U.S. Patent Application Serial No. 10/775,216
Response filed April 28, 2006
Reply to OA dated January 12, 2006

REMARKS

FIG. 9

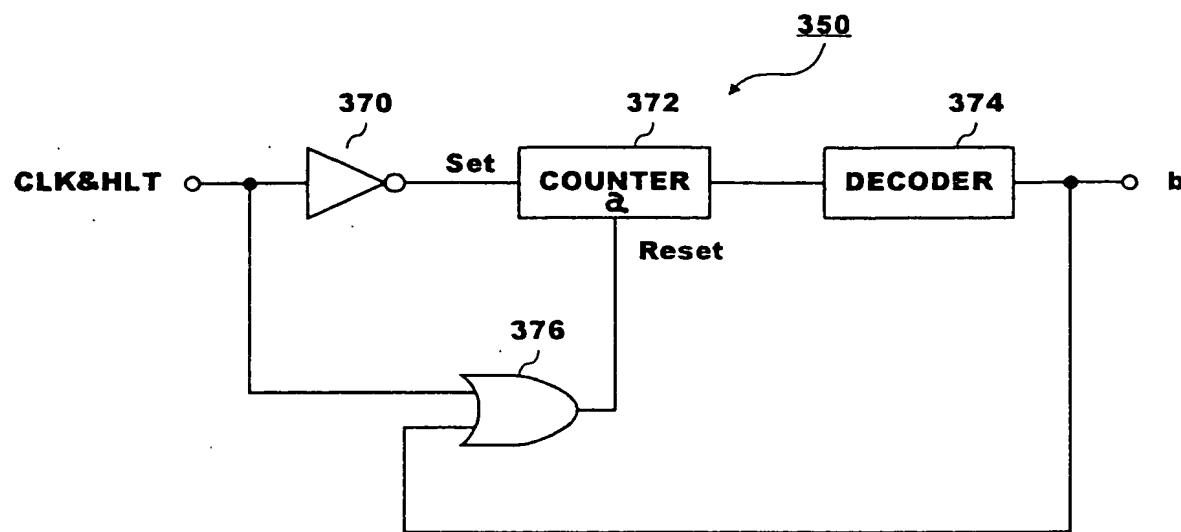
The Examiner objects to the drawings for the reasons set forth in item 1, page 2 of the outstanding Action. The Examiner suggests that the reference letter "a" be shown in the applicants' Figure 9. The applicants respectfully request reconsideration of this objection.

In Figure 9, the signal "b" is illustrated as an output signal of the decoder 374. However, signal "a" is neither an input signal or an output signal; that is, as described in line 7, page 17 of the applicants' specification, the signal "a" "shows a period in which the counter 372 shown in FIG. 9 conducts counting."

Nevertheless, in order to address the Examiner's concern concerning the illustration of signal "a" in the applicants' Figure 9, the applicants submit herewith a replacement sheet for Figure 9, which includes such reference signal designation "a" within the block box representing the counter 372.

In Fig. 9, reference notation “a” is included, as required by the Examiner, to show signal “a” to represent “a period in which the counter 372 shown in FIG. 9 conducts counting,” as described in the applicants’ specification (line 7, page 17).
